# System Unbalance Requirements

David Stover, Michael Paul

# Problem Statement: PSE Unbalance Requirements

# Proposed Remedy: 33.2.8.4.1 R<sub>PSE</sub> Test Method, Revised

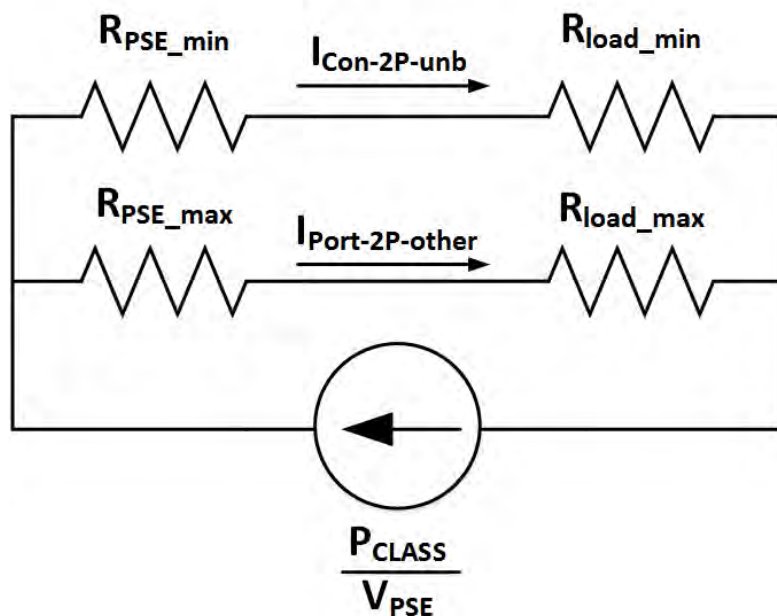
- R<sub>PSE</sub> unbalance is limited (Section 33.2.8.4.1)

– Section 33.3.8.10: “...R<sub>load\_min</sub> and R<sub>load\_max</sub>, where

$$R_{load\_max} = K_{class} * R_{load\_min}, \text{ and}$$

R<sub>load\_min</sub> is in the range of 0.168Ω to 5.28Ω...”

$$\frac{K_{class} * (R_{pse\_min} + R_{load\_min})}{R_{pse\_min} + R_{load\_min}} \leq \frac{I_{Con-2P-unb}}{I_{Port-2p-other}}$$

# Proposed Remedy: 33.3.8.10 $R_{PD}$ Test Method, Revised

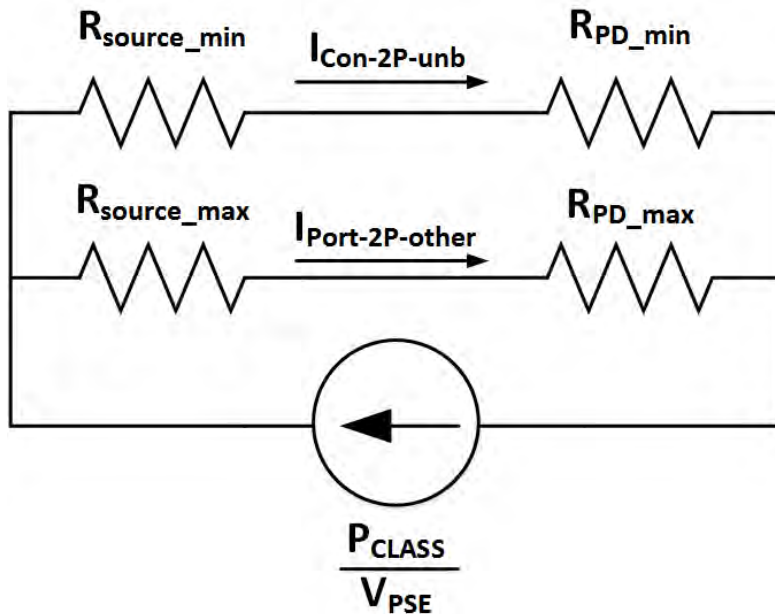
- $R_{PD}$  unbalance is limited (Section 33.3.8.10)

– Section 33.3.8.10: “... $R_{source\_min}$  and  $R_{source\_max}$ , where

$$R_{source\_max} = K_{class} * R_{source\_min}, \text{ and}$$

$R_{source\_min}$  is in the range of  $0.168\Omega$  to  $5.28\Omega$ ...”

$$\frac{K_{class} * (R_{pd\_min} + R_{source\_min})}{R_{pd\_min} + R_{source\_min}} \leq \frac{I_{Con-2P-unb}}{I_{Port-2p-other}}$$

# Problem #1

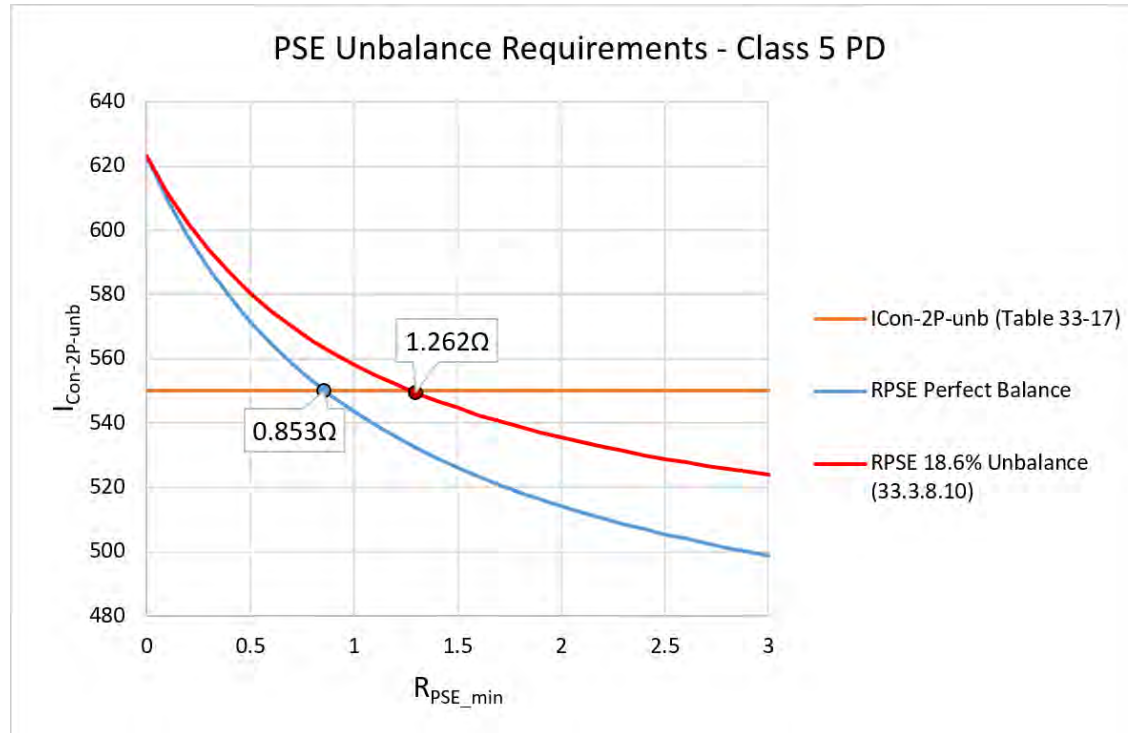
- PSEs with ideal balance require  $R_{PSE} \geq 0.853\Omega$  to achieve  $I_{Con-2P-unb}$  min
- Per 33.3.8.10, PDs are required to draw no greater than  $I_{Con-2P-unb}$  when connected to “ $R_{source}$ ” (unbalance ratio of 1.186:1)
  - This requirement places additional restrictions on the PSE, requiring PSEs with ideal balance to implement  $R_{PSE} \geq 1.262\Omega$

### Conflict: 33.3.8.10 $R_{PD}$ Test Method vs $I_{Con-2P-unb}$

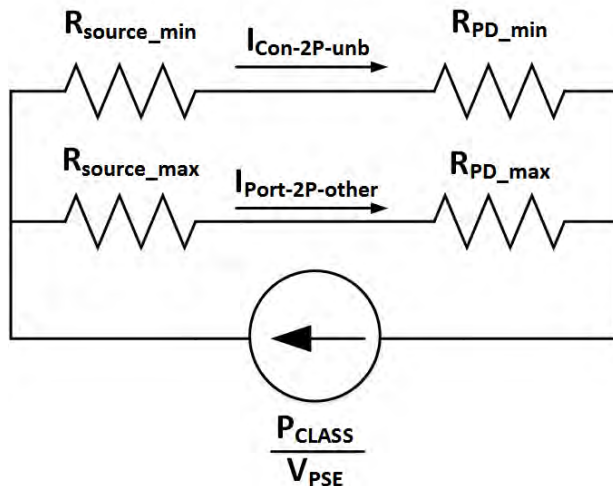
- $R_{PD}$  unbalance is limited (Section 33.3.8.10)
  - Section 33.3.8.10: "... $R_{source\_min}$  and  $R_{source\_max}$ , where  
 $R_{source\_max} = 1.186 * R_{source\_min}$ , and  
 $R_{source\_min}$  is in the range of  $0.168 \Omega$  to  $5.28\Omega$ ..."
  - $R_{source}$  ratio is 1.186:1
- $I_{Con-2P-unb}$  ratio is limited (slide 5)
  - **Class 8**  $I_{Con-2P-unb}$  ratio is 1.15:1
- $R_{PD}$  unbalance contribution must be **matched and large** to comply
  - or **actively balanced**
